Frequency modification on the TD-L1550:

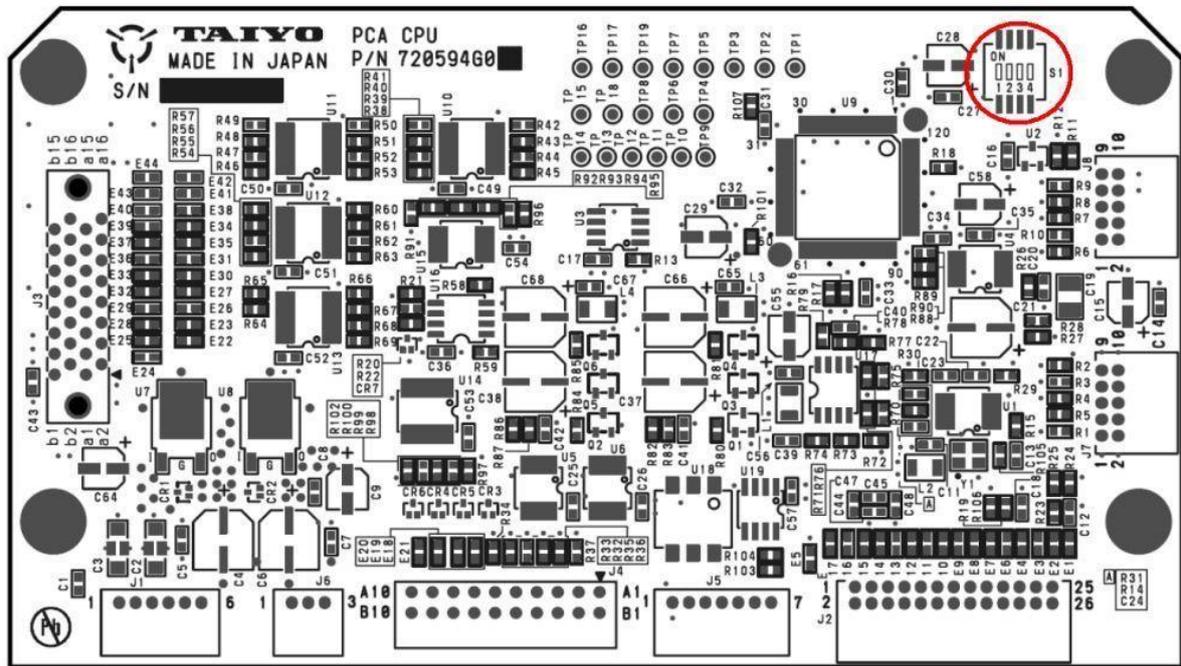
It is possible to switch regular TD-L1550A to TD-L1550A-MOB or vice versa by DIP switch S1-1 on PCA CPU. Regular TD-L1550A is "ON" and TD-L1550A-MOB shall be "OFF" position on S1-1 DIP switch. After changing the main unit to TD-L1550A-MOB, turning on the power pressing a numeral key, "8". Then, "E1" is displayed on the channel. That means that the unit can DF for 121.65 MHz only. Please find attached file for the position of S1-1 DIP switch on PCA CPU.
